**PHASE 1 HVAC IMPROVEMENTS AT THE
LP WILSON COMMUNITY CENTER
601 MATIANUK AVENUE
WINDSOR, CT 06095**

S/P+A PROJECT NO. 21.288

DATE: December 22, 2022

Drawing Title:
**MECHANICAL
CEILING WORK PLAN
AREAS A & B**

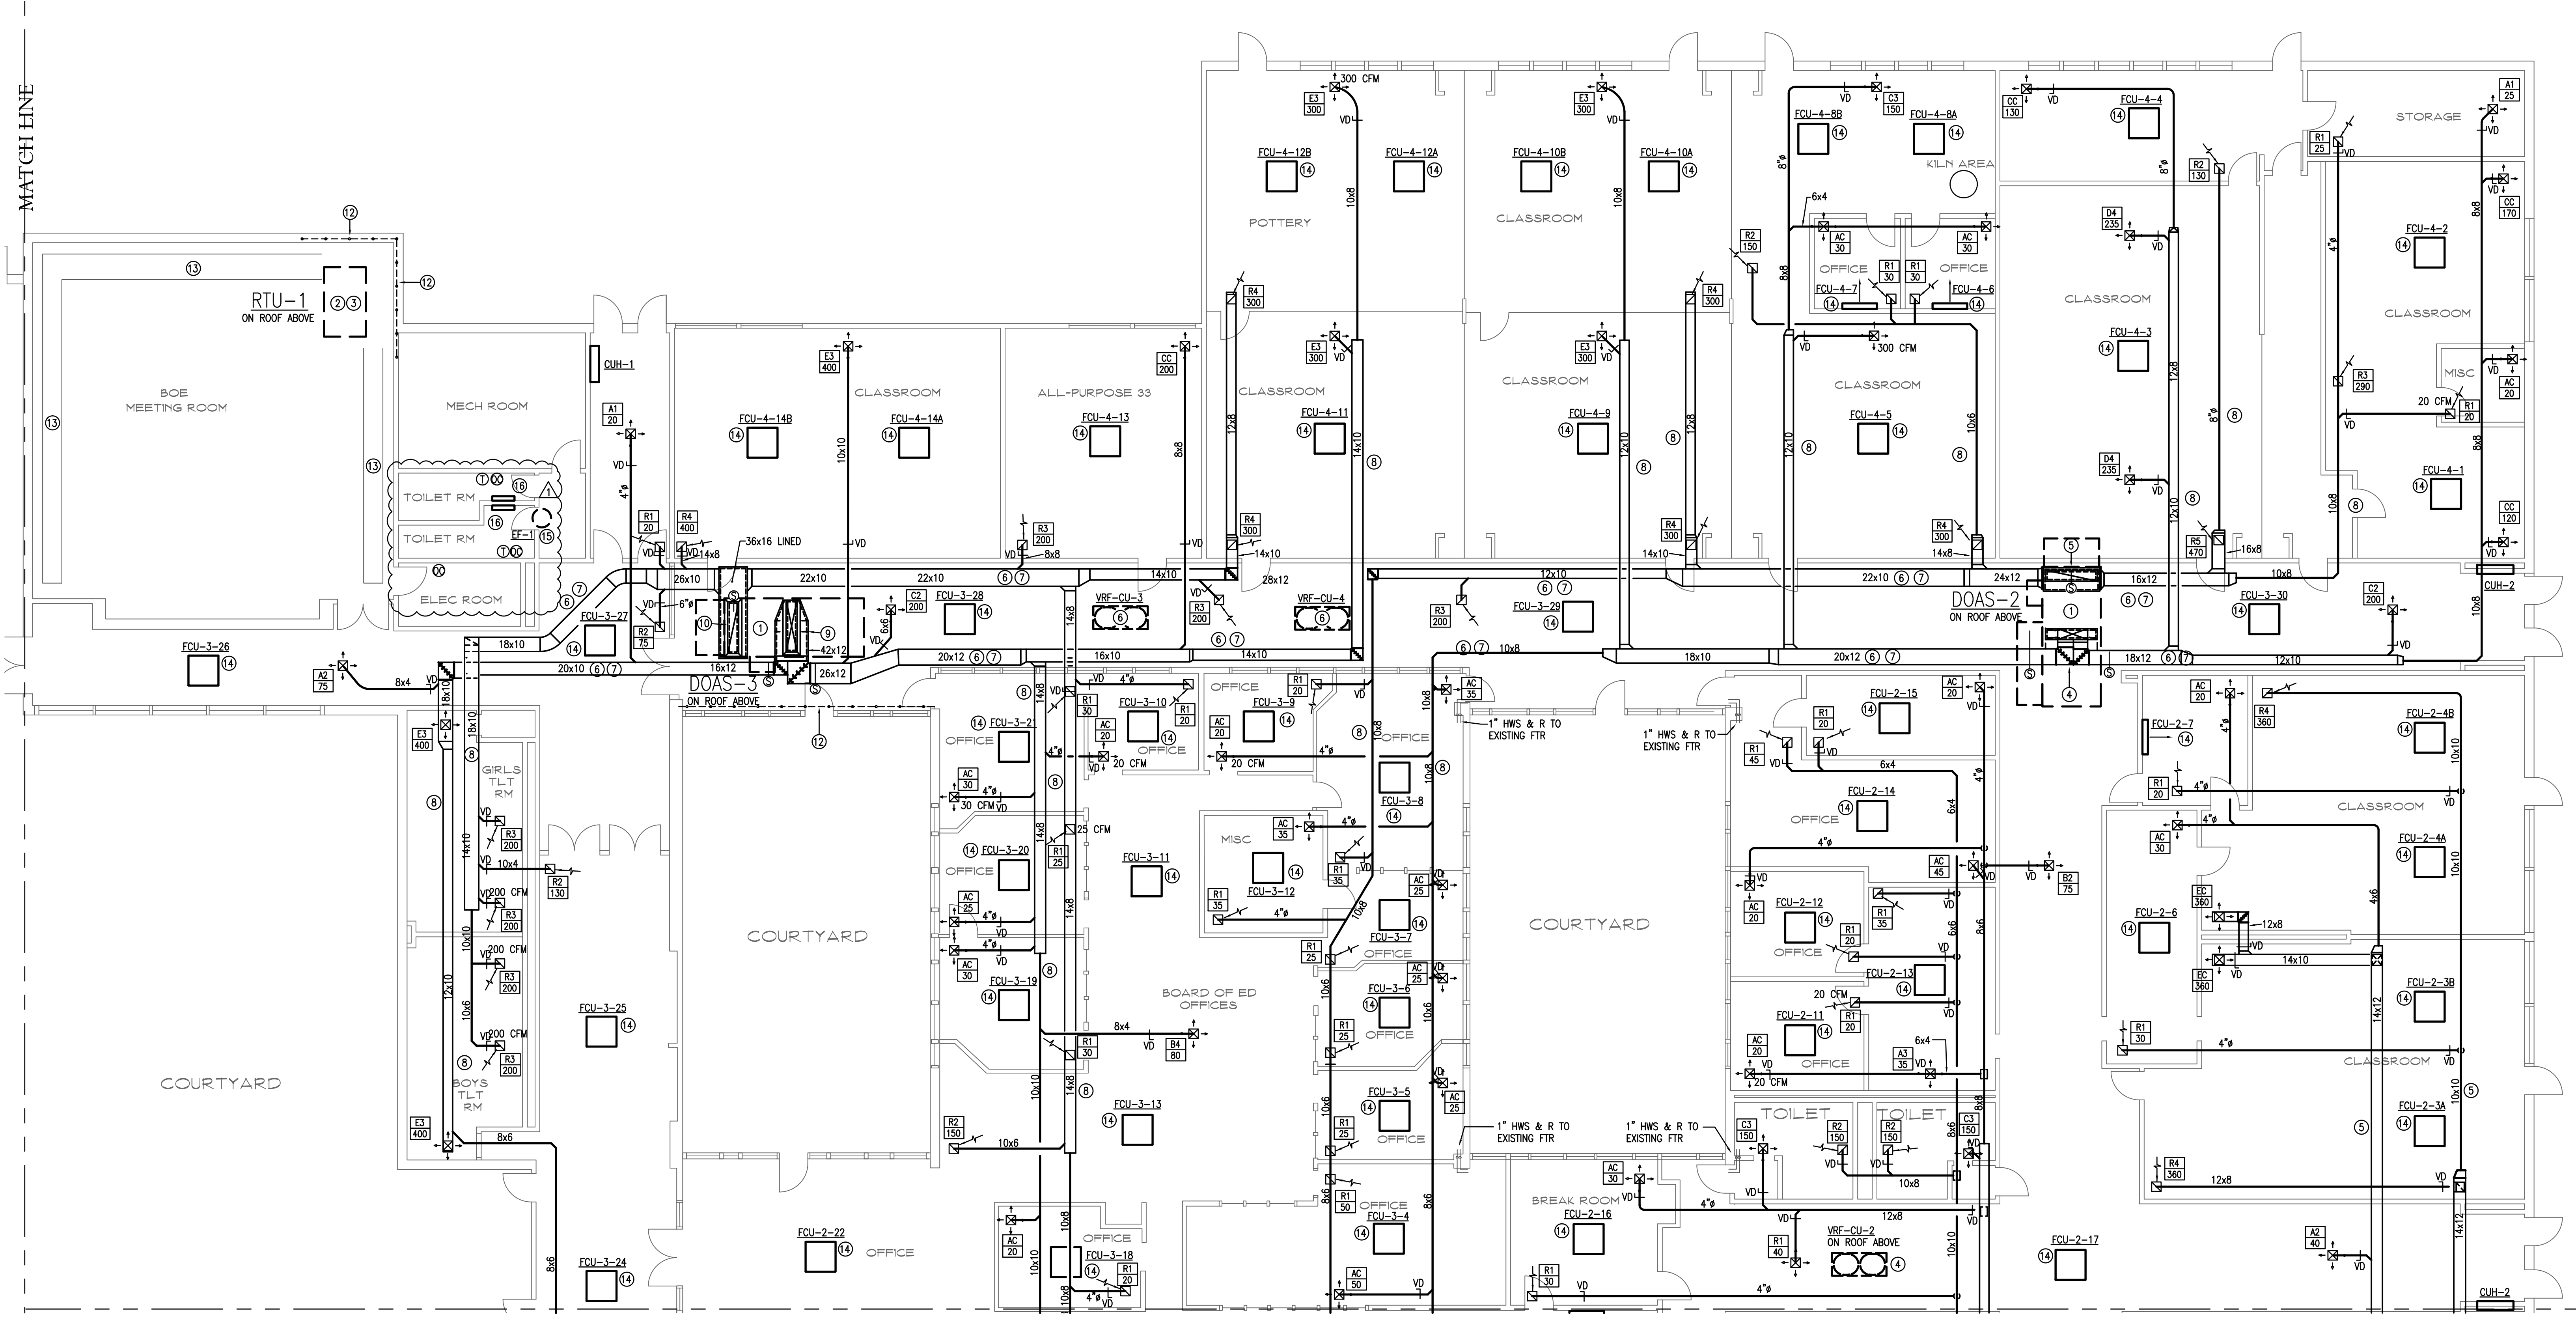
Add: Drawing M104 “Mechanical Ceiling Work Plan”, attached as part of this Addendum.

006	Note (1) on drawing E102 says that there are (45) 120V circuits between the 1" & 1 1/4" conduit we need to remove/relocate. By code, we cannot accomplish that without more conduits. We are only allowed to run (3) circuits per conduit without having to upsize the wire/and or conduit. I can do what the drawing says, but there will most certainly be a change order right off the bat in this case.	12/19/22	Use of #10 AWG conductors for the 120V circuits would address any conductor derating required. Base the bids on the assumption that all 120V circuits are run with #10 AWG.	1
007	Is there a wire/conduit requirement for sizing of feeders for panels MDP-2, H-1 & H-2? Thanks.	12/12/22	See Rev-1 of Drawing E003 issued with Addendum 1.	1
008	Please provide a detail showing the area of the building that would require the existing drop ceiling to be removed and a new ceiling to be installed	12/15/22	Refer to Drawing M104, attached as part of this Addendum.	1

- 1 CEILING IN THIS ROOM/AREA IS TO BE REMOVED AND REPLACED WITH NEW GRID AND TILES UPON COMPLETION OF NEW MECHANICAL WORK. REFER TO CEILING REPLACEMENT NOTES, THIS DRAWING.
- 2 SOFFIT IN THIS ROOM IS TO BE REMOVED AND REPLACED AS REQUIRED TO REMOVE EXISTING AIR HANDLING UNIT AND DUCTWORK. REPLACE SOFFIT WITH NEW GRID AND TILES UPON COMPLETION OF NEW MECHANICAL WORK. REFER TO CEILING REPLACEMENT NOTES, THIS DRAWING.

- 1. CONTRACTOR SHALL REMOVE CEILING TILES AND GRIDS AS REQUIRED TO PERFORM INSTALLATION OF NEW MECHANICAL SYSTEMS. REPLACE ALL CEILING TILES AND GRIDS WITH NEW MATERIALS UPON COMPLETION OF INSTALLATION.

- 2. REMOVE AND STORE ALL CEILING DEVICES IN CEILINGS BEING REMOVED. REINSTALL ALL EXISTING CEILING DEVICES IN NEW CEILINGS. DEVICES TO BE REINSTALLED INCLUDE, BUT ARE NOT LIMITED TO LIGHT FIXTURES, EXIT SIGNS, HEAT/SMOKE DETECTORS, SPEAKERS, ALARM DEVICES, REMOTE TEST SWITCHES, MOTION SENSORS, PROJECTORS, ETC. NUMBERS SHOWN IN EACH SPACE ARE FOR (L) LIGHTS AND (M) MISC MOTION SENSORS, DETECTORS, ETC.

- 3. ERECT TEMPORARY SMOKE BARRIERS WHERE REMOVAL OF CEILINGS WILL ALLOW SMOKE TO MIGRATE TO ADJACENT CORRIDORS OR EXIT ACCESS WHEN PORTIONS OF BUILDING WILL BE OCCUPIED DURING CONSTRUCTION. COORDINATE WITH FIRE DEPARTMENT.

- 4. TEMPORARILY RELOCATE SPRINKLER HEADS IN AREAS WHERE CEILINGS ARE REMOVED TO WITHIN 12" OF ROOF DECK. REINSTALL SPRINKLER HEADS IN NEW CEILING TILES.

- 5. ELECTRICAL DEVICE QUANTITIES LISTED ON THIS DRAWING ARE INTENDED TO BE IN ADDITION TO THOSE NOTED ON DRAWINGS E101 & E102, NOTE #1.
